Access Compliance Report

Public Rights-of-Way

(Pedestrian Signals)

Intersection ID: N/A	Main Street:	Cross Street: N/A	Location: N/A
ADA ID: 5EF587914785	Signal Type: Two Push Buttons-APS	Overall Compliance: No	Severity Score: BTN 1:N/A BTN 2: N/A No BTN: N/A
Codes/Mitigation Info/Possible Solution		Field Measurements/Component Compliance

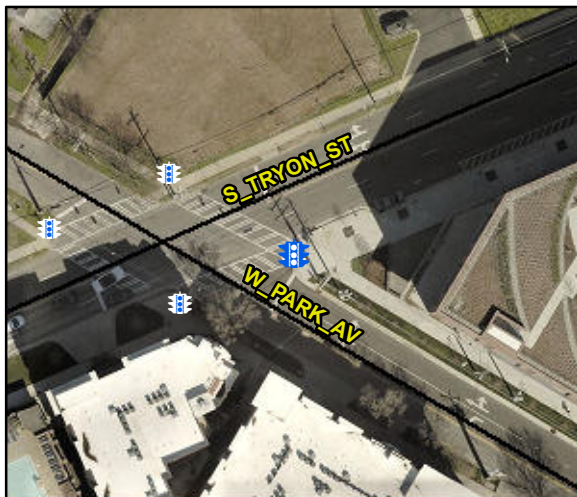
PROW/ADA: TMUTCD 4e.08, R404.3, R406.2, , R404.2, R404.7.3

N/A	B 1 FWD Approach Obstruction?	Yes	N/A	B 2 FWD Approach Obstruction?	Yes
N/A	B 1 FWD Approach Obstruction Dist (in)	3.0	N/A	B 2 FWD Approach ObstructionDist (in)	N/A
N/A	B 1 PARA Approach?	Yes	N/A	B 2 PARA Approach?	Yes
N/A	B 1 PARA Approach Constrained?	No	N/A	B 2 PARA Approach Constrained?	No
Yes	B 1 PARA Approach Reach (in)	6.0	No	B 2 PARA Approach Reach (in)	14.0
N/A	B 1 PARA Approach Width (in)	N/A	N/A	B 2 PARA Approach Width (in)	N/A
N/A	B 1 PARA Approach Obstruction?	Yes	N/A	B 2 PARA Approach Obstruction?	Yes
N/A	B 1 PARA Approach Obstruction Dist (in)	3.0	N/A	B 2 PARA Approach ObstructionDist (in)	12.0
Yes	B 1 Clear Floor Space Slope (%)	1.4	No	B 2 Clear Floor Space Slope (%)	2.2
Yes	B 1 Clear Floor Space XSlope (%)	0.9	Yes	B 2 Clear Floor Space XSlope (%)	1.1
N/A	B 1 PAR Slope (%)	3.9	N/A	B 2 PAR Slope (%)	0.8
Yes	B 1 Height (in)	43.0	Yes	B 2 Height (in)	43.0
Yes	B 1 Pressure (#)	2.0	Yes	B 2 Pressure (#)	2.0

Yes	B 1 Clear Xing Direction?	ClearlyMarked	Yes	B 2 Clear Xing Direction?	ClearlyMarked
	B 1 Crossing Direction	To NW		B 2 Crossing Direction	To SW
No	B 1 DistanceTo XWalk (in)	61.0	Yes	B 2 DistanceTo XWalk (in)	0.0
No	B 1 DistanceTo Curb (in)	121.0	No	B 2 DistanceTo Curb (in)	121.0
Yes	B 1 Diameter (in)	2.0	Yes	B 2 Diameter (in)	2.0

Possible Solutions: Replace Signal Push Button With APS Button on New Post. Remove & Relocate Sign.
